# CITY OF ALBUQUERQUE

RE: **Lot 12 Block 5 Volcano Cliffs Unit 19 SAD 228**  
**6500 Kimmick Rd. NW**  
**Grading and Drainage Plan**  
**Engineers Stamp Date 11/9/2020 (D10D003M19)**  
**Pad Certification Date 1/21/2021**

## DRAINAGE AND TRANSPORTATION INFORMATION SHEET (REV 6/2018)

ENGINEER'S SEAL	6500 KIMMICK	DRAWN BY WCWJ
		DATE 11-07-20
	GRADING AND DRAINAGE PLAN	2102093-LAYOUT-11-07-20
	11/9/20	 <div>Rio Grande Engineering 1606 CENTRAL AVENUE SE SUITE 201 ALBUQUERQUE, NM 87106 (505) 872-0999</div>
DAVID SOULE P.E. #14522		JOB # 2102093

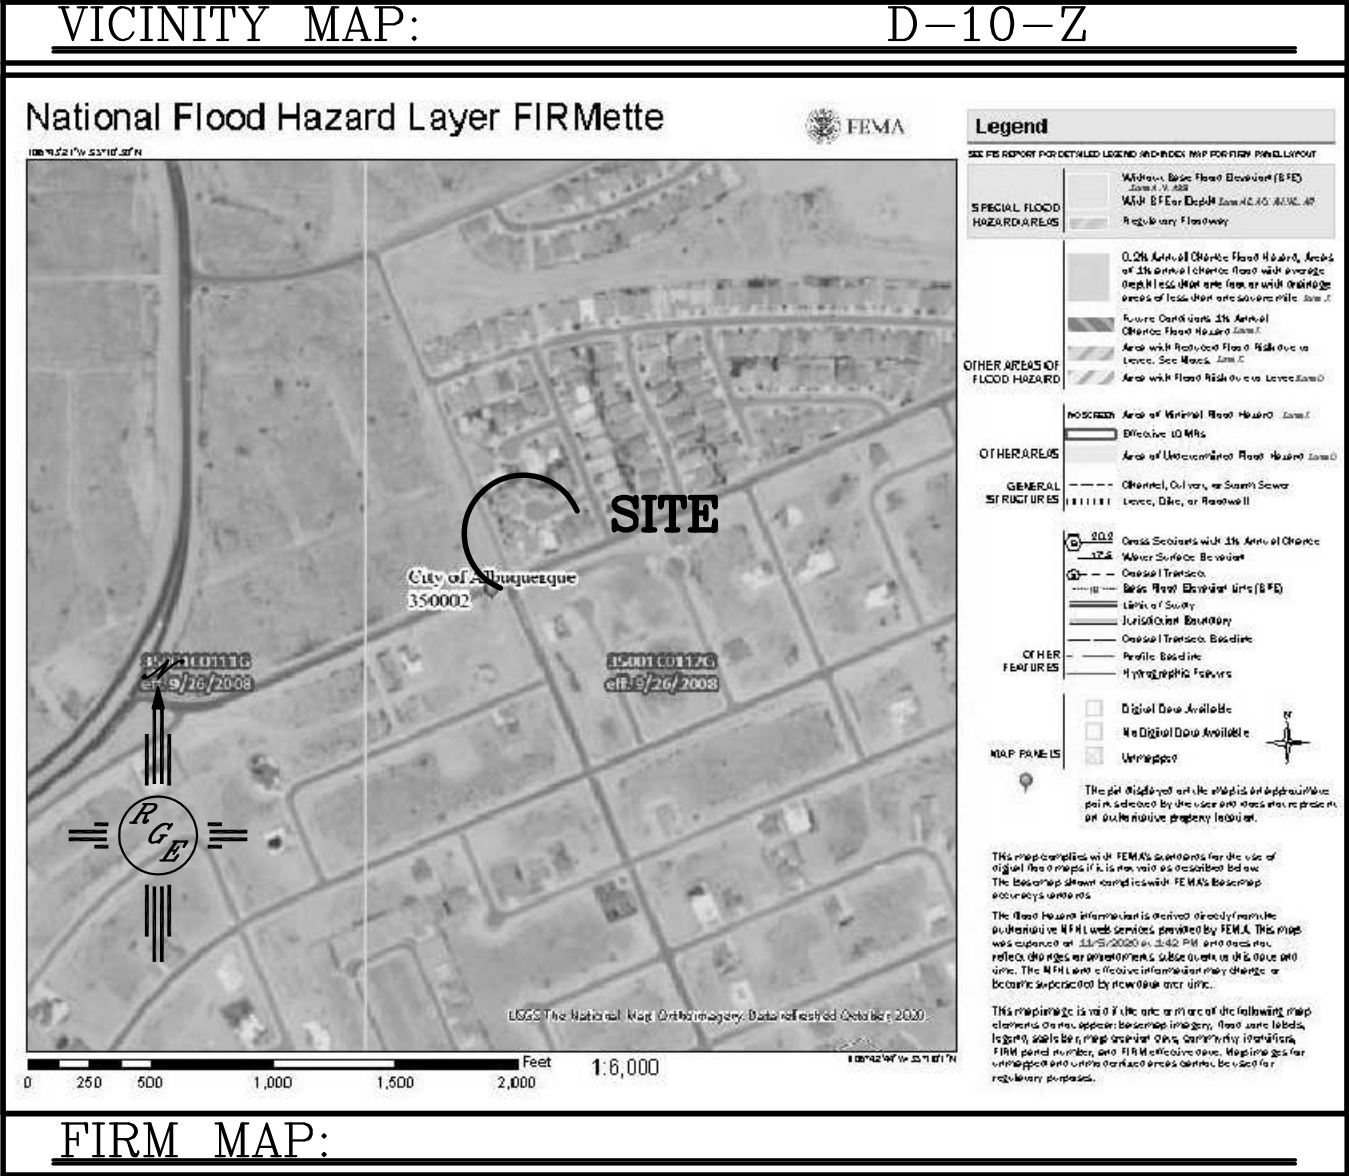
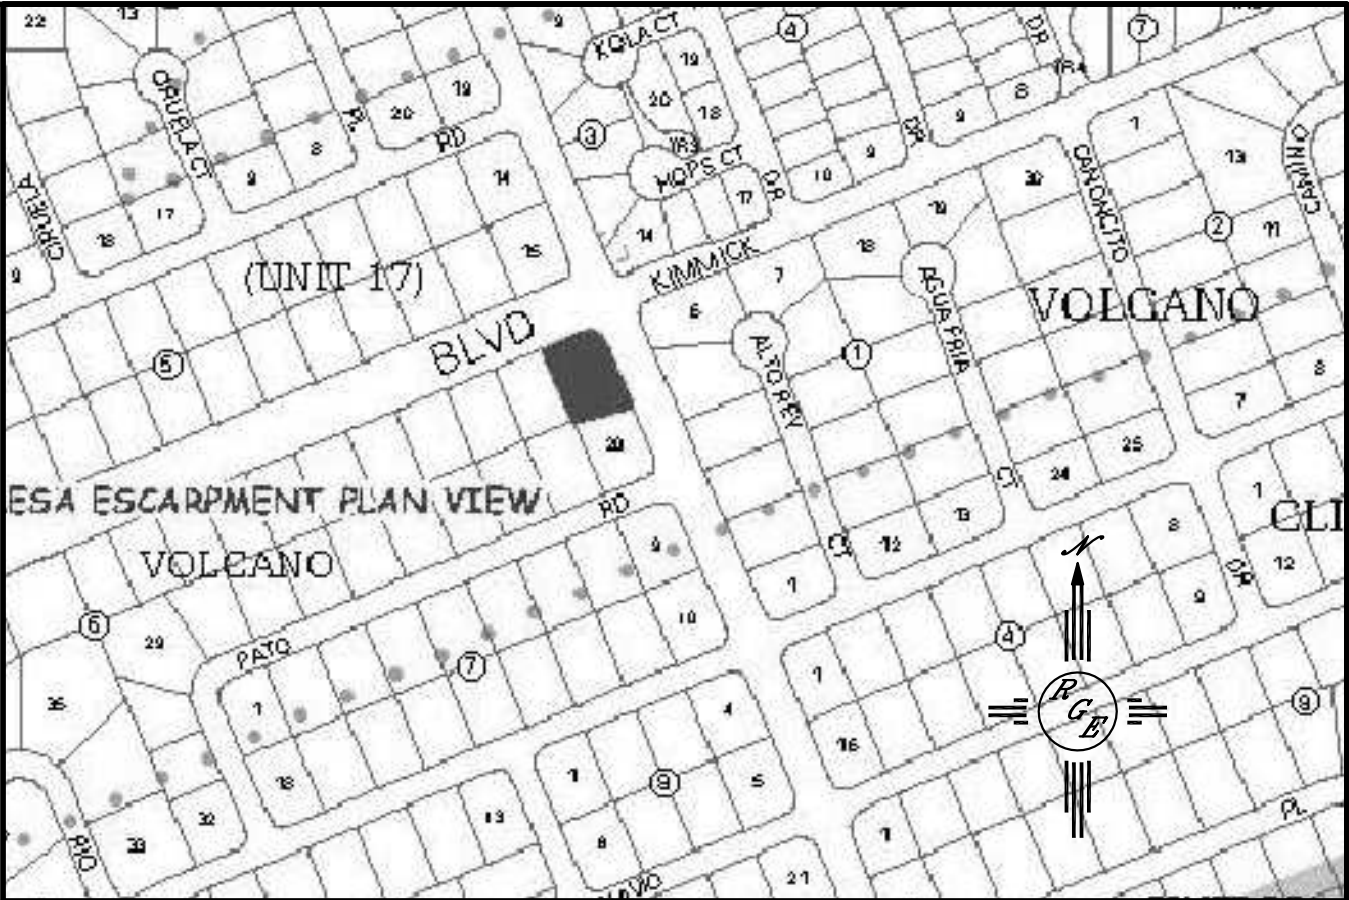
Based upon the information provided in your submittal received 1/22/2021, this plan is approved for Building Permit.

**Reiterate to the Owner/Contractor that a separate permit for a garden/retaining wall must be obtained, with the approved G&D plan and Pad Certification. Also, let the owner/contractor know that if a pool is to be added in the future the G&D plan will need to be modified showing the location of the pool and the land treatment differences.**

Prior to Certificate of Occupancy release, Engineer Certification per the DPM checklist of this plan will be required.
